Results of LMSC Ballot on Draft Standard 802.11 D5.0

Resolutions for Comments on Clause 8

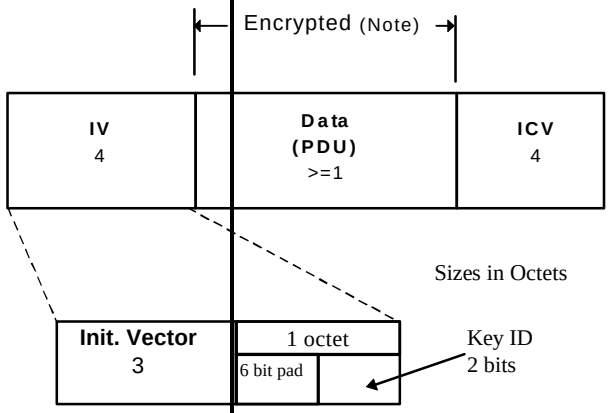
19	**8.2.5**	**RM**	**T**	**Y**	**Section 8.25 and Figure 35 are contradictory:** **From Section 8.2.5** The key ID occupies the two least significant bits of the last octet of the IV field, while the pad occupies the six most significant bits of this octet. **From Section 7.1.1 Conventions** ..... The least significant bit of each octet is defined as bit 0 for that octet and is the **leftmost** bit of the octet (except the FCS field). Figure 35 shows the key ID as the rightmost 2 bits.	**Revise Section 8.2.5** The key ID occupies the two ~~most~~ least significant bits of the last octet of the IV field, while the pad occupies the six least ~~most~~ significant bits of this octet [alternatively, correction of the figure is acceptable]	**accepted - text corrected.**
20	8.2.5	SB	E	N	The type of CRC for the ICV and the transmission order are undefined	Amend 8.2.5 as follows, or to capture this intent: The WEP ICV ~~= 32 bits~~ shall be a 32-bit field containing the 32-bit Cyclic Redundancy Check (CRC) defined in	Accepted.

25	**8.2.5 (figure 35)**	**MAF**	**E**	**(na)**	**Text was added to the 2nd paragraph of Clause 8.2.5 at the July 1996 meeting to clarify IV field bit ordering by referring explicitly to the ordering conventions in Clause 7.1.1. However, Figure 35 was not updated to show the key ID bits at the left side of their octet, which is needed for consistency with the order stated in the text: "The key ID occupies the two least significant bits of the last octet of the IV field, while the pad occupies the six most significant bits of this octet."** **(I had to convert the drawing from its original format to "Word 6.0 Picture Object" before Word 6 for the Macintosh would let me edit the drawing. It may be perferable to make equivalnet changes in the original drawing rather than inserting the picture object to the right in place of the existing Figure 35.)**	Replacement for Figure 35 drawing:	**Accepted**

Seq. #	Clause number	your voter's ID code	Cmnt type E, e, T, t	Part of NO vote	Comment/Rationale	Recommended change	Disposition/Rebuttal
						clause 7.1.3.6 calculated over the Data (PDU) field as depicted in figure 35. The expanded MPDU shall include a 32 bit IV field immediately preceding the MPDU. This field shall contain three sub-fields: A three octet field that contains the initialization vector, a 2 bit key ID field and a 6 bit pad field. The ordering conventions defined in clause 7.1.1 apply to the IV fields and its sub-fields and to the ICV field.	
21	8.2.5	SB	E	N	There would seem to be an error in figure 35 since the figure does not match the statement: *The key ID occupies the two least significant bits of the last octet of the IV field, while the pad occupies the six most significant bits of this octet.*	Edit figure 35 to show the KeyID and pad as follows Key ID | 6-bit pad	test and figure are now consistent.
